MITIGATION PLAN

LAUREL VALLEY MITIGATION SITE

Burke County, NC
NCDEQ Contract No. 7875-02
DMS ID No. 100140

SUBJECT: NCDMS Laurel Valley Mitigation Project - NCIRT Comments during 30-day Mitigation Plan Review, Burke County, NC

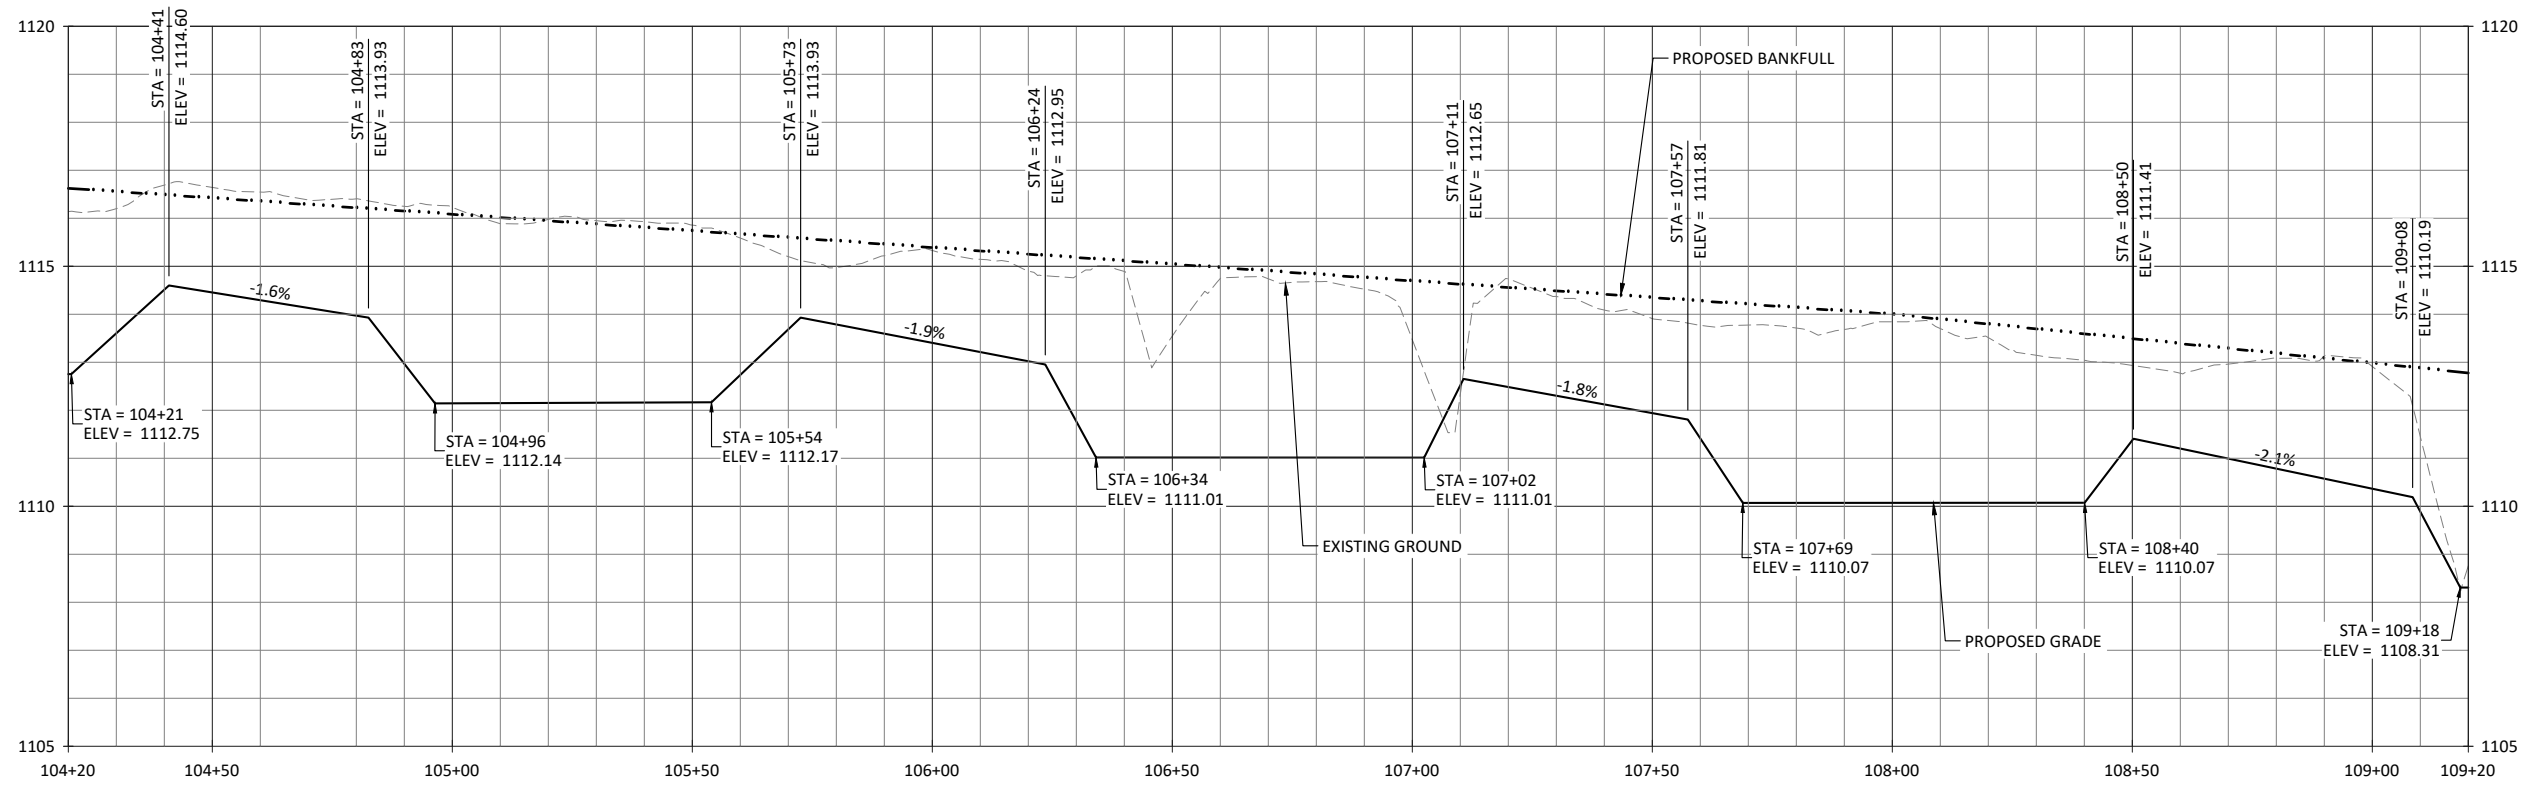
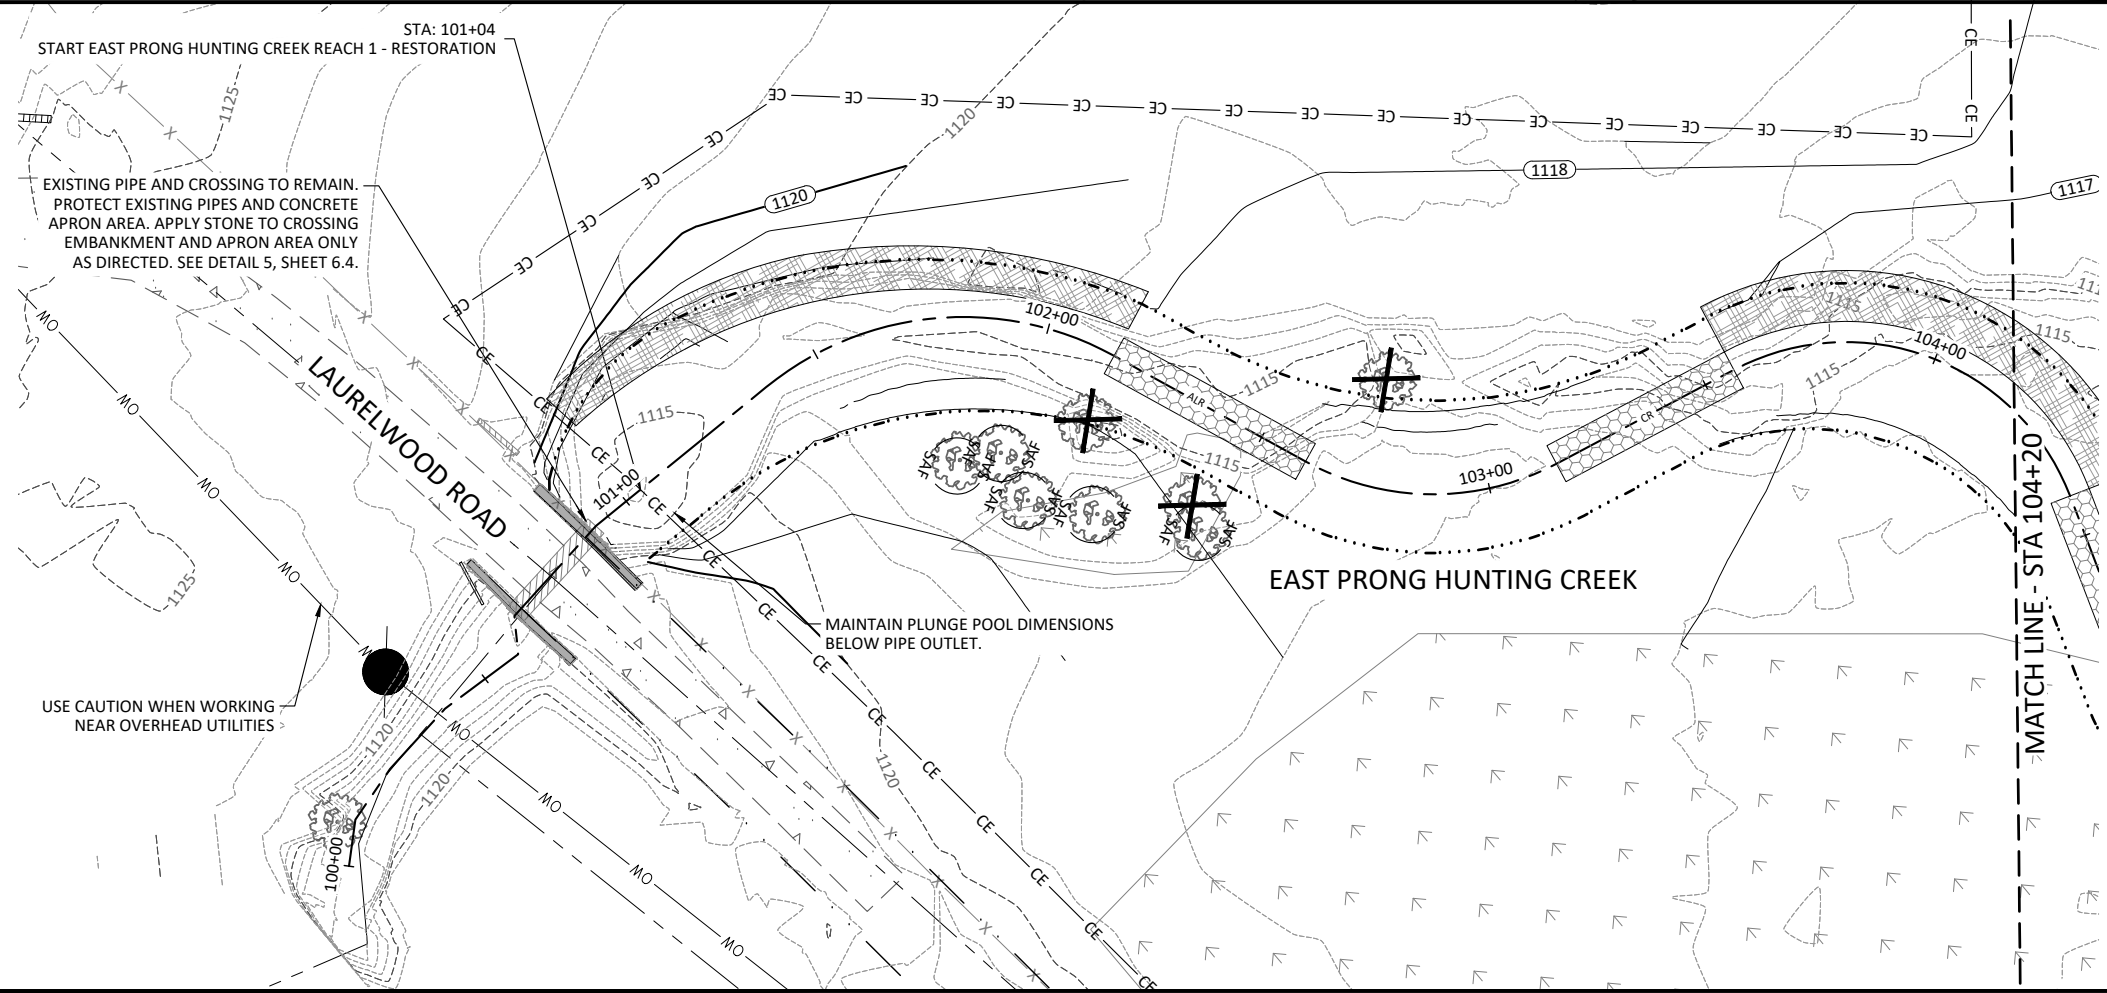
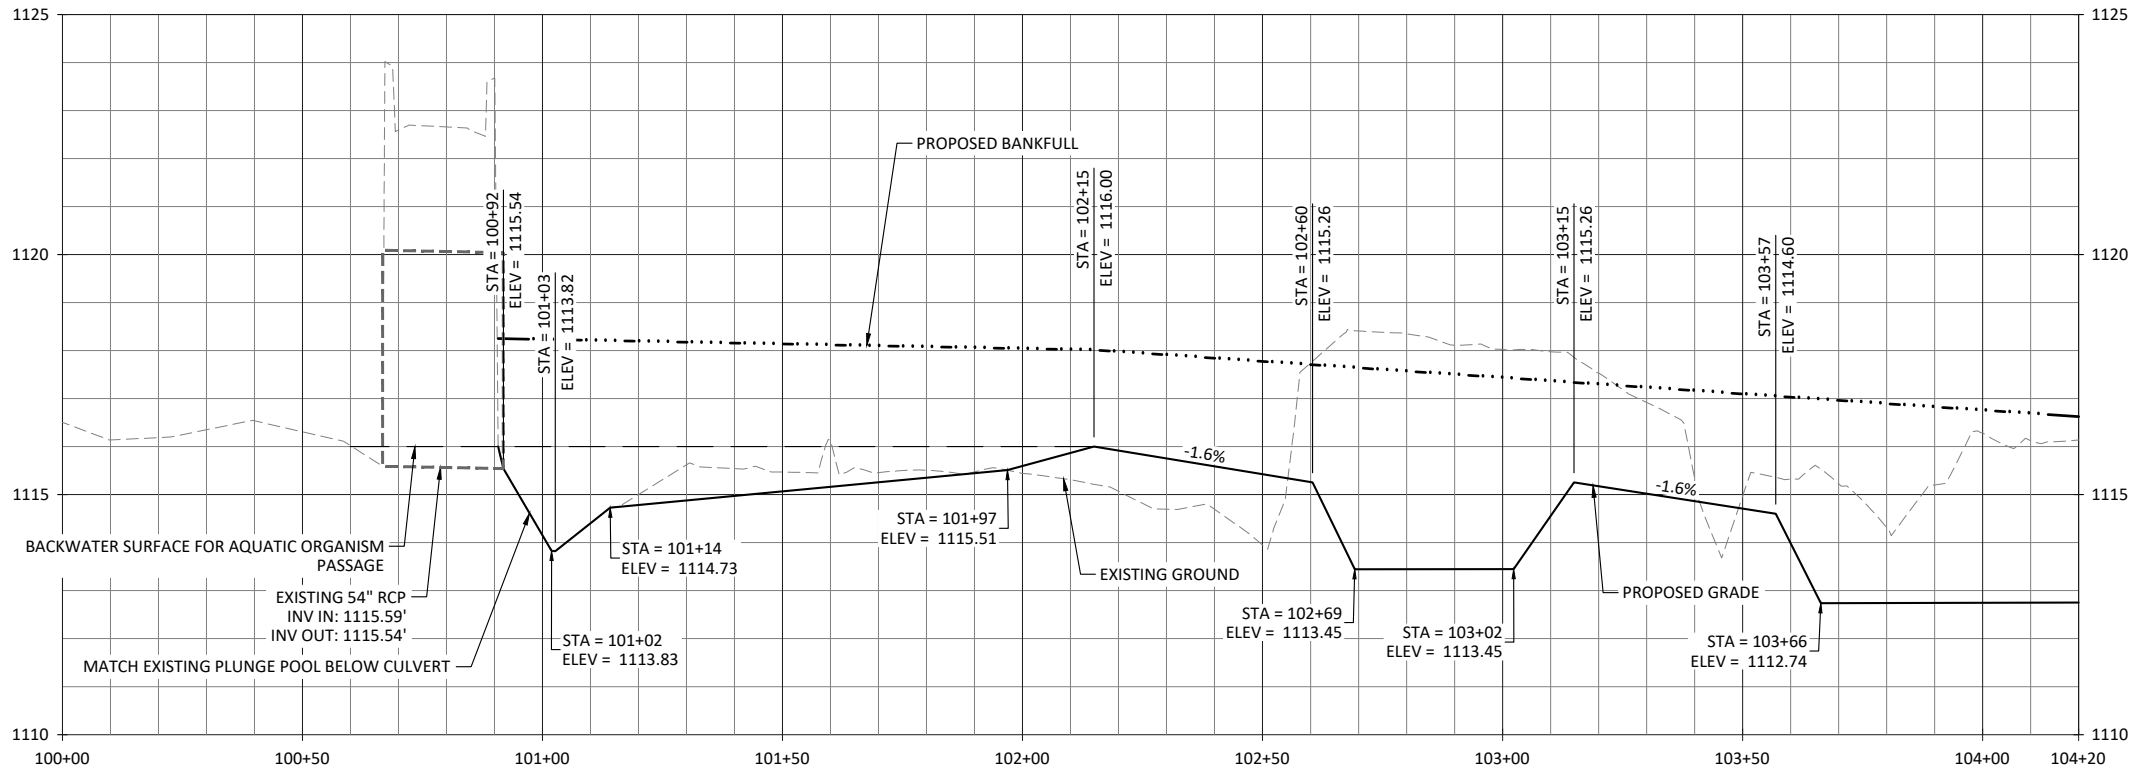
Section 6.6.1 East Prong Hunting Creek & Sheet 2.1.1: This section describes the plunge pool at the beginning of the project as an area with major erosion that may require additional rock as determined during construction. Please describe the potential rock stabilization method that could be applied to this area and label the plunge pool on Sheet 2.1.1 and consider adding a detail sheet for the potential rock stabilization structure.

- *Section 6.6.1 East Prong Hunting Creek & Sheet 2.1.1: This section describes the plunge pool at the beginning of the project as an area with major erosion that may require additional rock as determined during construction. Please describe the potential rock stabilization method that could be applied to this area and label the plunge pool on Sheet 2.1.1 and consider adding a detail sheet for the potential rock stabilization structure.*

areas. After re-grading the eroded area, stone will be applied to reduce the potential for the problem to re-occur. Note that the embankment areas that may receive this stone (the crossing at the beginning of East Prong Hunting Creek Reach 1 and the crossing at the beginning of UT1 Reach 2) are located outside the conservation easement. Stone will only be applied to the crossing embankment while erosion along the outer banks of the plunge pools will be addressed by grading, brush/rock/geo-lifts, and planting. The plunge pools throughout the project were labeled in the planset (Sheet 2.1.1 and 2.2.2) and additional notes were added that stone would only be applied to the crossing embankment. A detail was added to sheet 5.4 in the Plans.

The mitigation plan currently mentions "The plunge pool transitions to the typical meander pool dimensions and then a constructed riffle, the head of which was set at an elevation to increase the water surface through the culvert and reduce the perched condition of the culvert to improve aquatic organism passage." The elevation of the first head of riffle was set so that water would back into the existing culvert. Backwater surface profiles were added to Sheet 2.1.1 and 2.2.2.
